Staff Presentation to the  
**Portland Design Commission**

**LU15-259773 DA**

**North18**  
**1126 NW 18TH Avenue, Mixed-use**

January 28, 2016

## MOD #1 **Height Standards** (33.140.210)

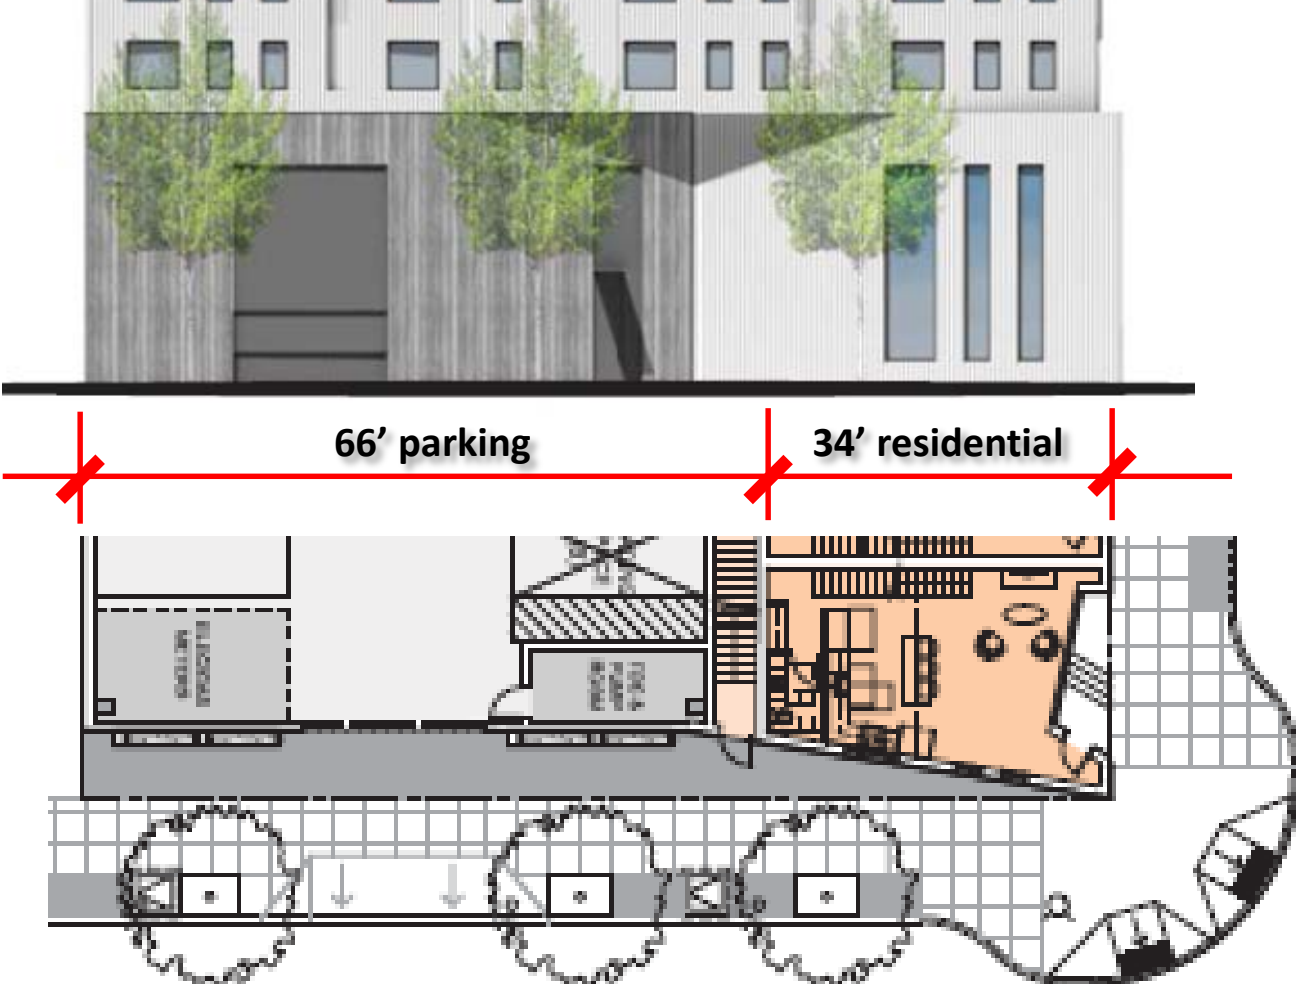
*7 floors are proposed (including mezzanine), therefore parapet may be at or above the 75' maximum limit. Additionally, a rooftop terrace will require guardrails which will add to the height of the building.*

## MOD #3 Ground Floor Active Use (33.562.240)

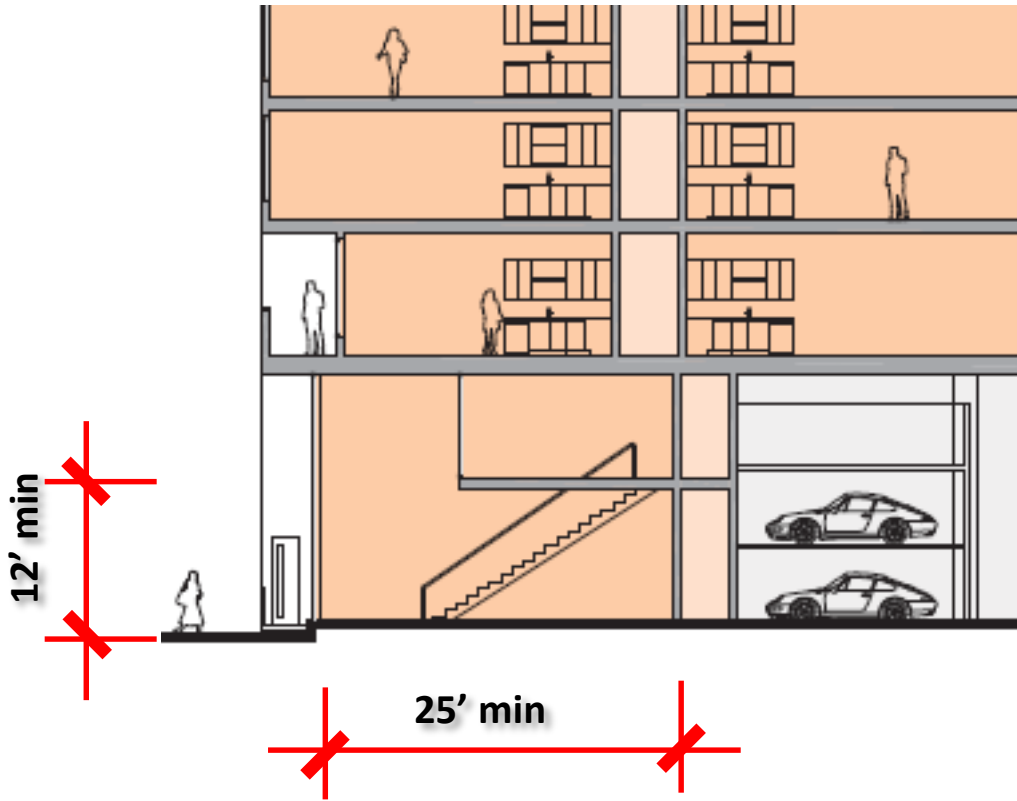
*Along NW Northrup, active use standards apply requiring 25' depth and 12' clearance.*

*Possible modification needed below mezzanines, depending on final structure and floor heights.*

### Design Exception for **Garage Door Setback**

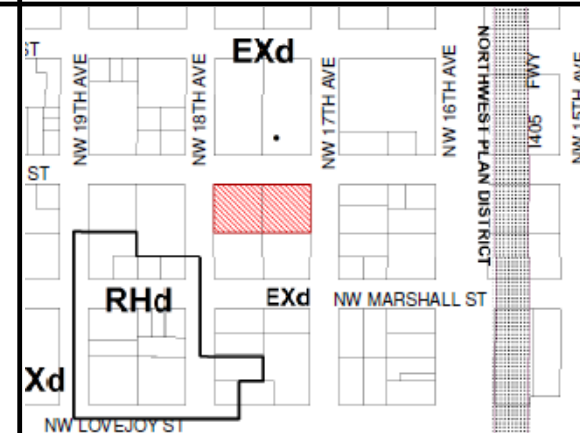
*Proposal indicates door at about 5 feet from sidewalk.*

*PBOT requires driveway gates to be located 20 feet beyond the back of the sidewalk. A design exception is required though PBOT to locate gate closer.*

**Canopy**

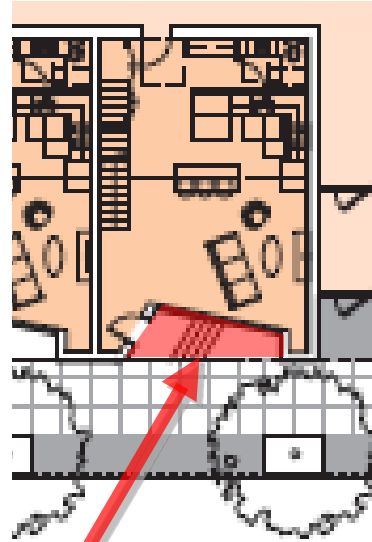
*Do the small canopies over the retail entrances and the second floor overhangs providing sufficient pedestrian protection?*

**Stoops**

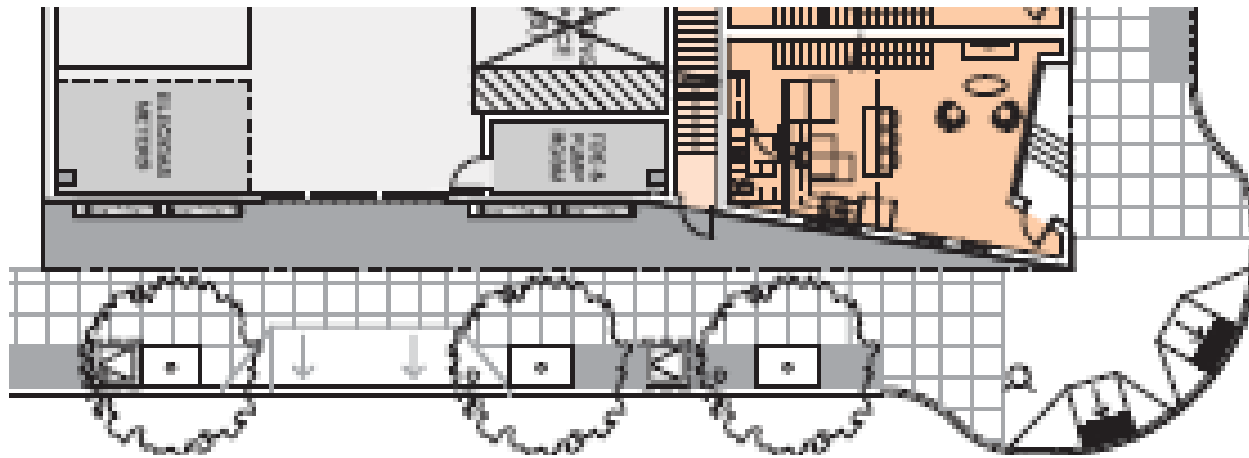
*Do the townhouse stoops provide sufficient size and separation from the sidewalk to encourage residents to maintain active connections to the street?*

*Does the 66' of frontage of parking & services contribute enough to the vitality of NW 17<sup>th</sup>?*
